MALUHIA, A LONG TERM HEALTH CARE FACILITY
HAWAII HEALTH SYSTEMS CORPORATION

SUBJECT: Addendum No. 1
IFB No. 22M-0324 Maluhia – Dayroom Projects

Addendum No. 1

From: Curtis K. Miyamura
CKM Architects, LLC
Date: April 4, 2022
Re: Drawings and Specifications for Maluhia – Hospital Dayroom Projects
1027 Hala Drive
Honolulu, Oahu, Hawaii
TMK: 1-6-009:004

FOUNDATION PLAN

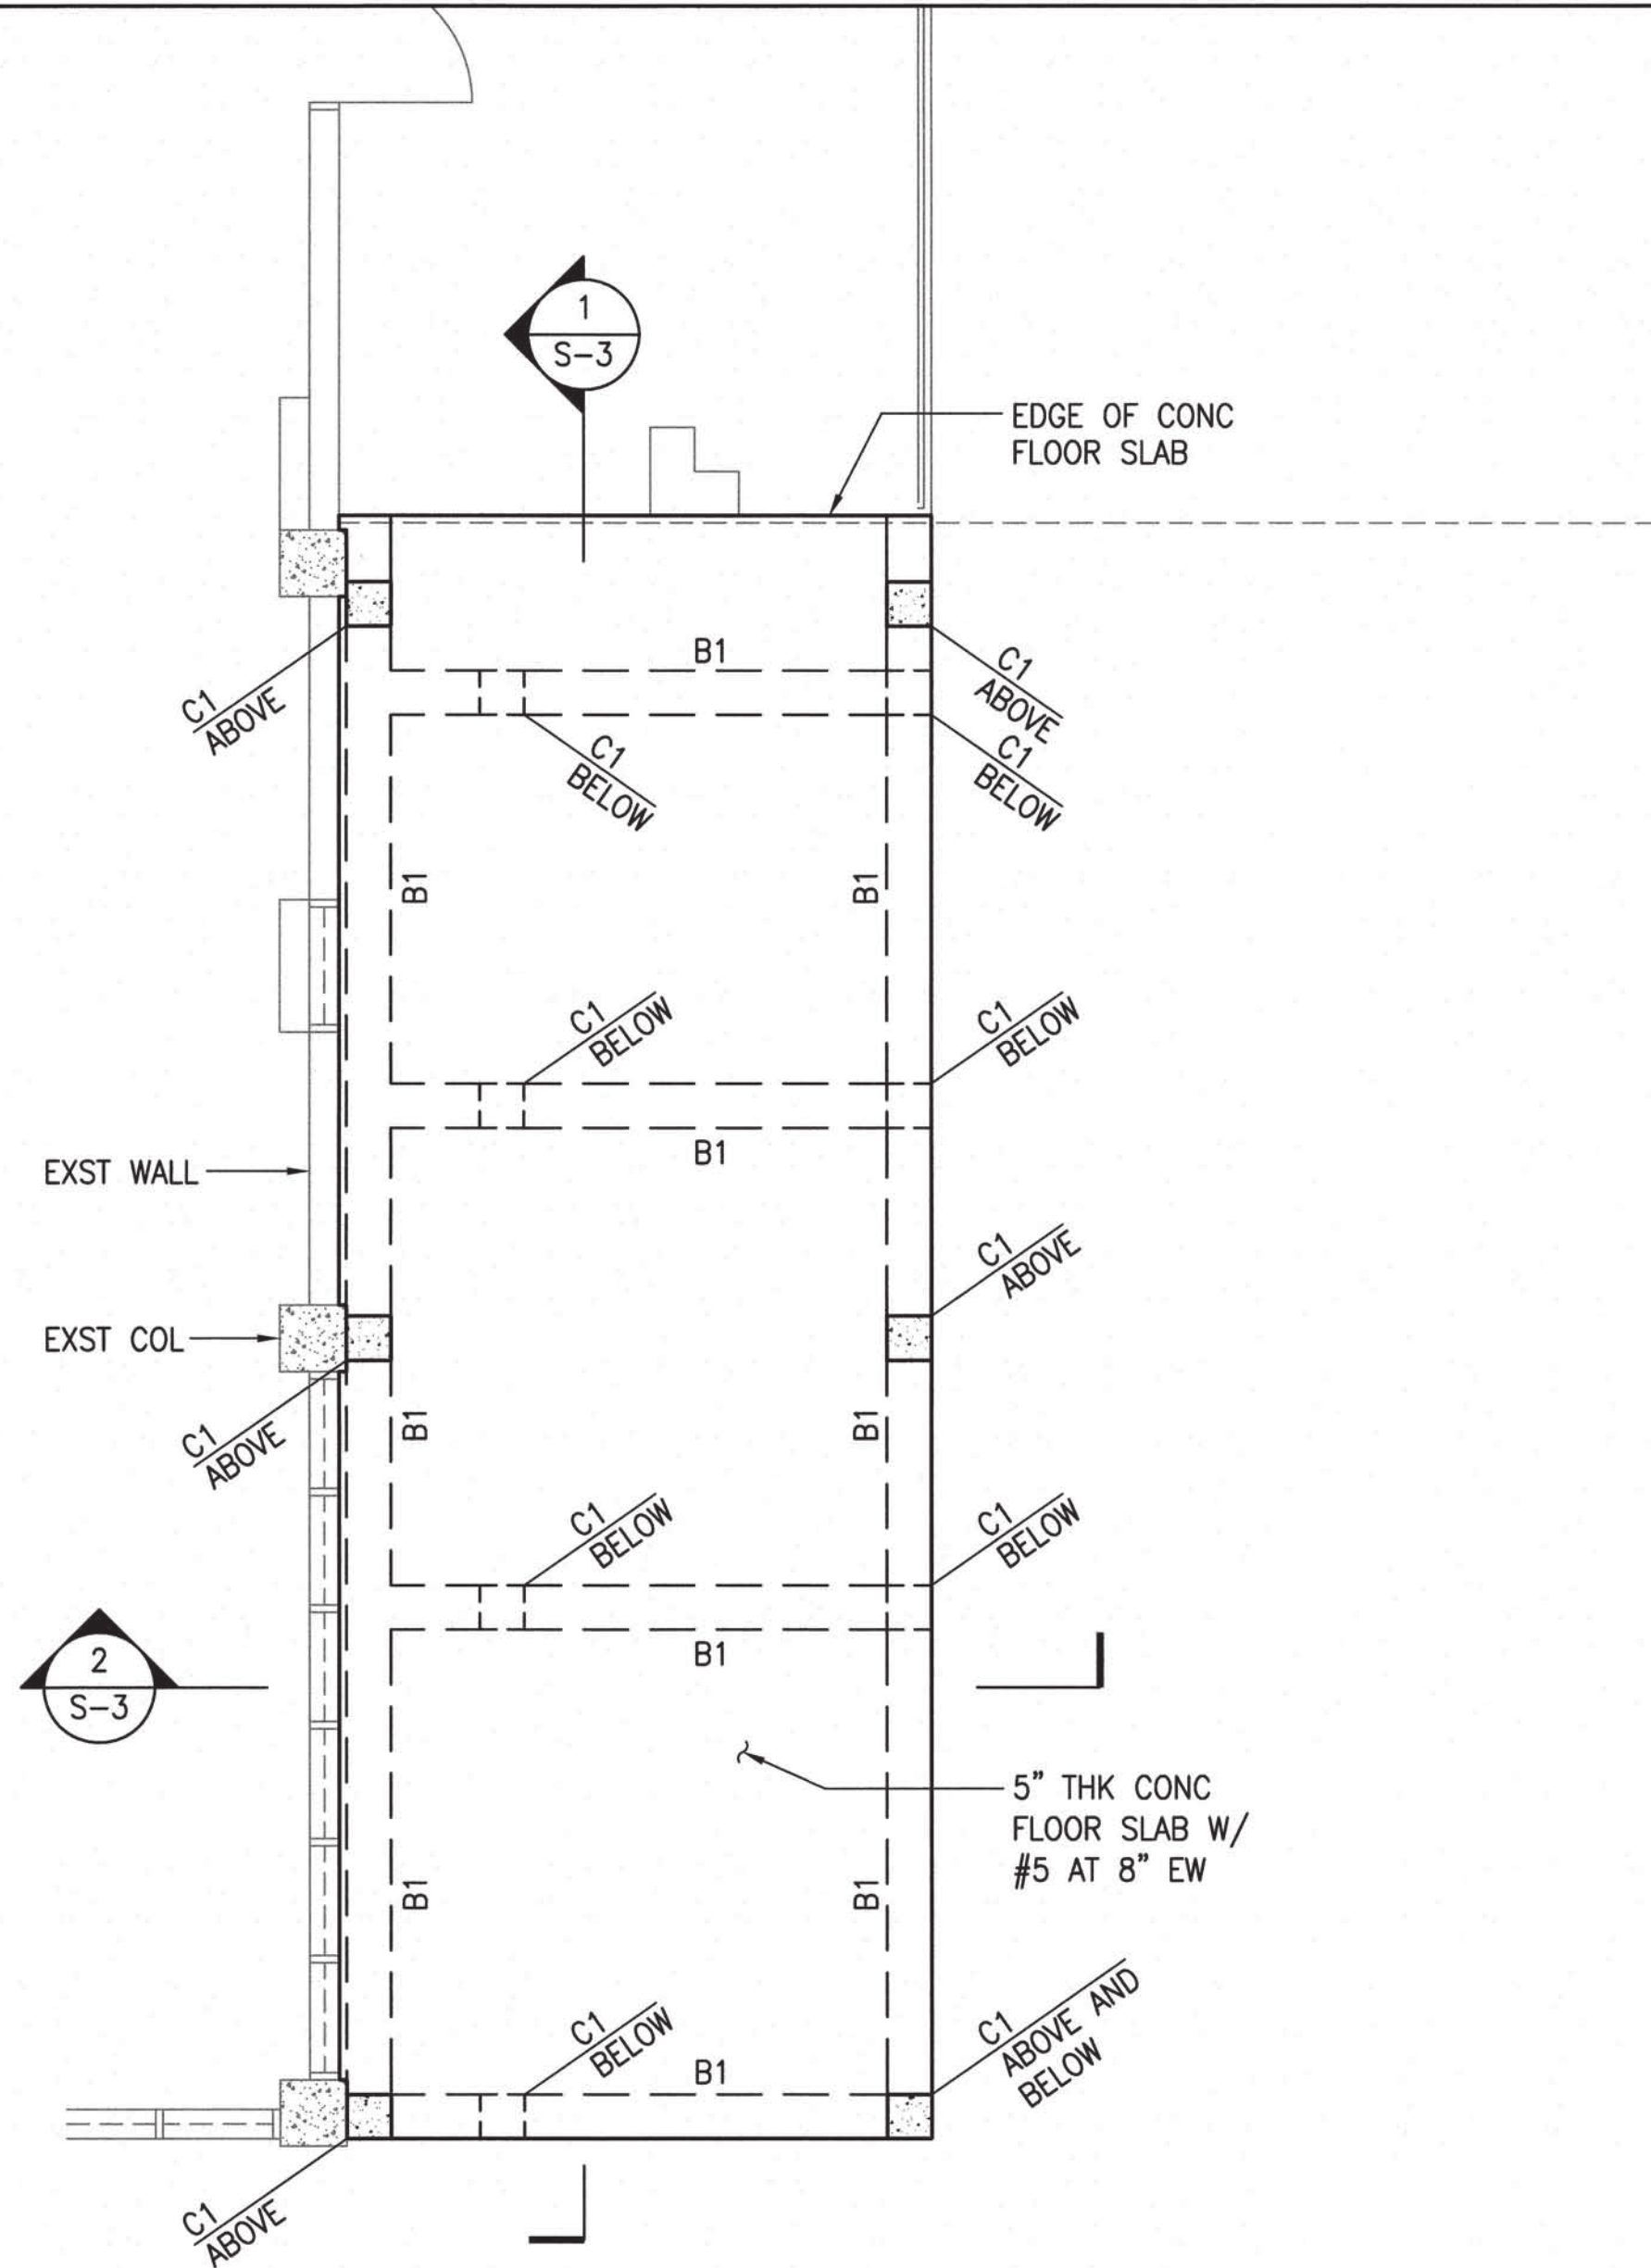
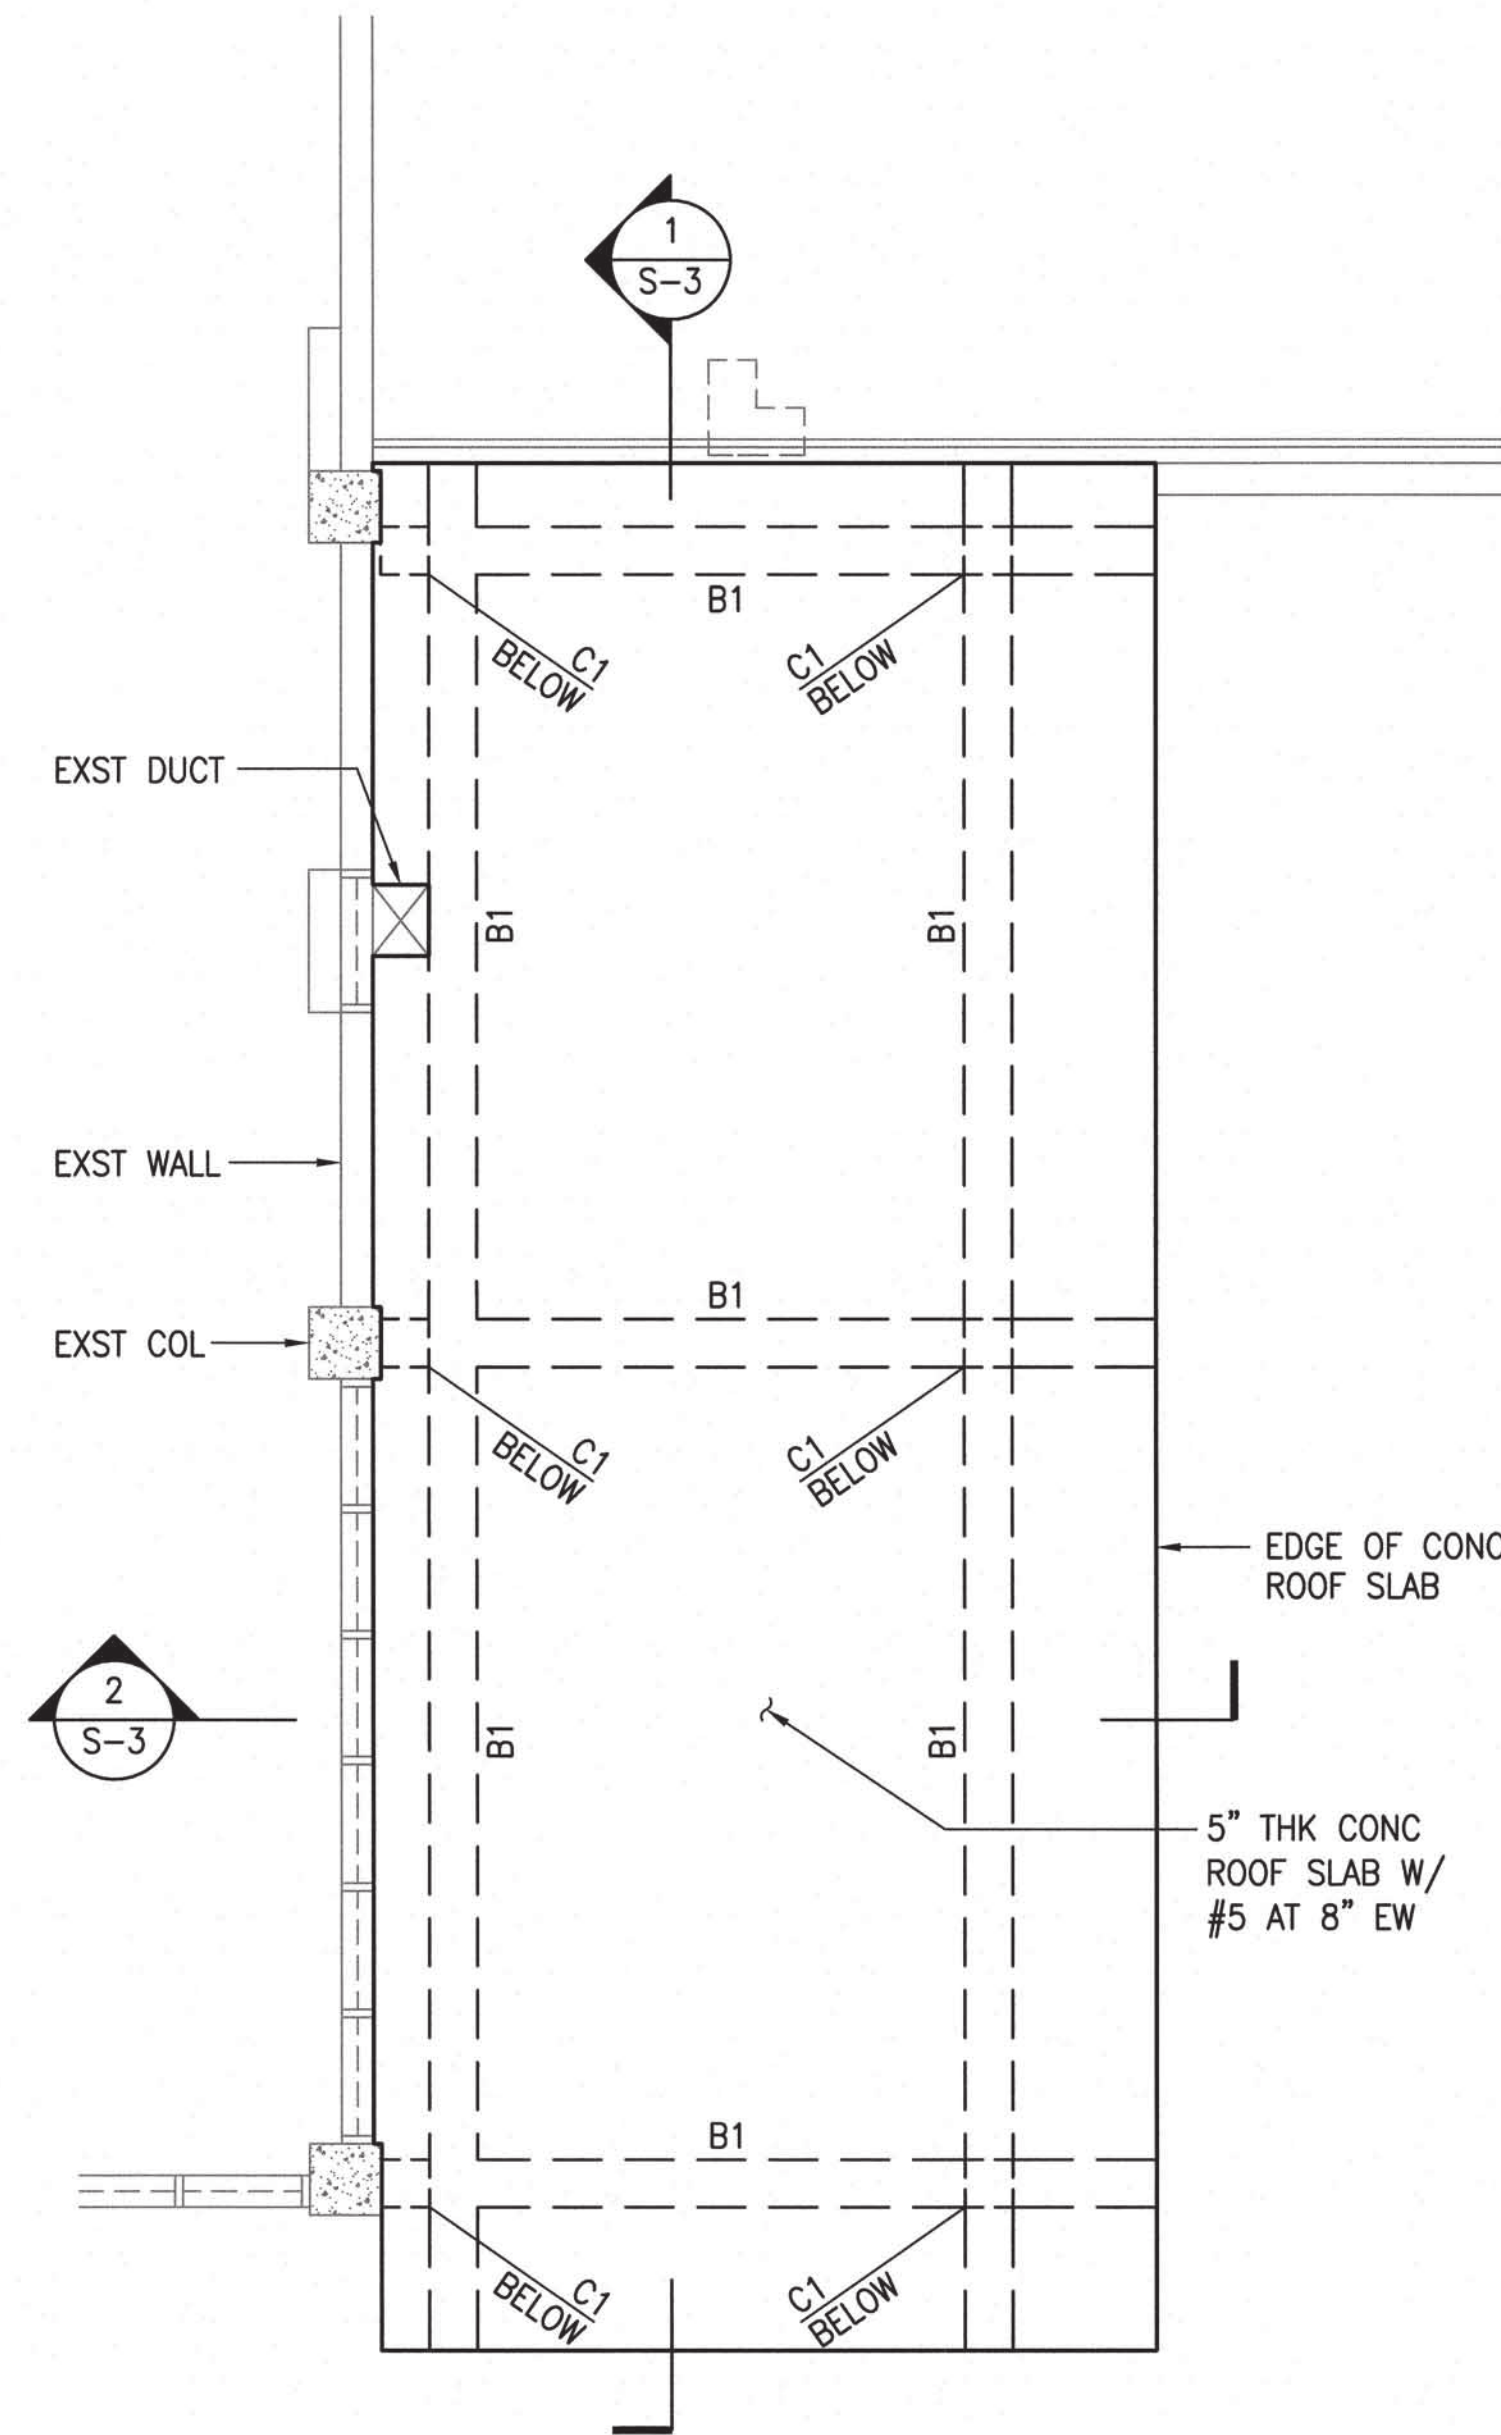
6. Reference new covered deck area: **Drawings in Addendum 1 addresses the questions for items 6a – 6e.**
 - a. Please provide details for new concrete (footing, slab, columns, beams, suspended roof deck) work (dimensions, reinforcing, etc.)

- b. Please provide subgrade preparation requirements. Noted that the footprint area beneath the new covered deck has a slope concrete ramp, an existing CMU retaining wall and an asphalt parking area.

- c. Is there a tied connection between the new concrete roof and existing concrete deck? Noted that there is an existing gutter and downspout along the face of the existing concrete deck.

- d. Along the existing building side (west side), the area below the new slab is open to structure below. Please provide details for infilling the open area if the area beneath the new slab is to be filled and tamped per A/A-4.
